CATEGORY: Upgrade advised when next maintaining cams or bearings

Summary: Carnaud Metalbox Engineering Ltd is recommending the implementation of clamp rings on the redraw cams of all Bodymakers.

NOTE: For further information regarding this Technical Bulletin please contact either of the contacts below quoting technical bulletin number **TB5000-069** and your machine Serial Number. A complete library of technical bulletins are available on the company web site.

Fig 1: Nordlock washers locking principle

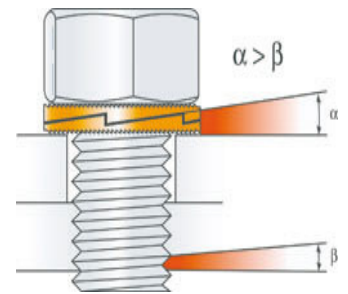
The clamp rings perform two functions; the first, to allow anti-vibration Nordlock washers (Fig 1) to be applied to a surface other than the hardened cam face, this offers extra security to the fixings around the cam. The second function is to prevent the dowel pins becoming loose during continued operation.

Fig 2: Redraw Cam Clamp Ring Overview

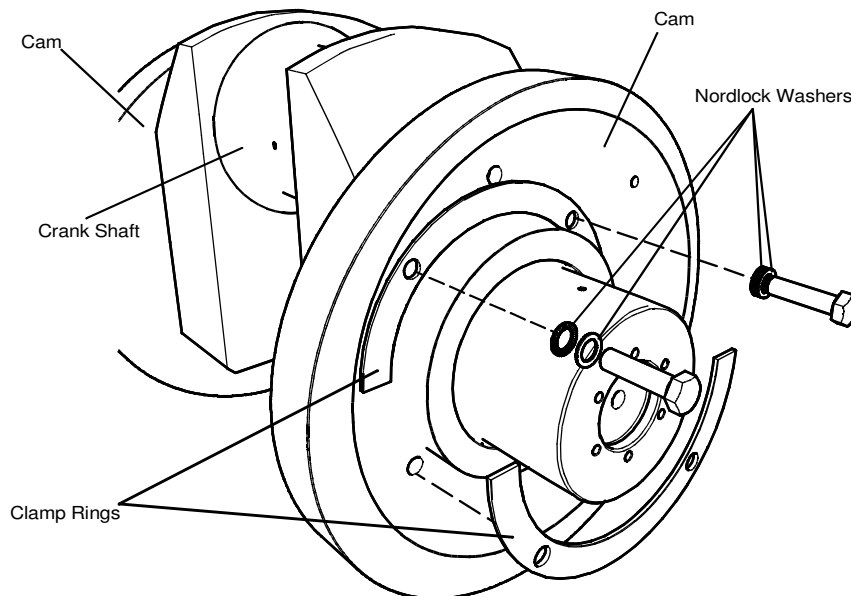
The clamp ring comes in two separate, semi-circular pieces (Fig 2). These separate pieces negate the need to completely remove the redraw cam from the crankcase housing, however, due to the limited access in this area, it will still be necessary to remove several main components, including the main bearing and primary connecting rod. As such, this maintenance upgrade must only be carried out by suitable service engineers.
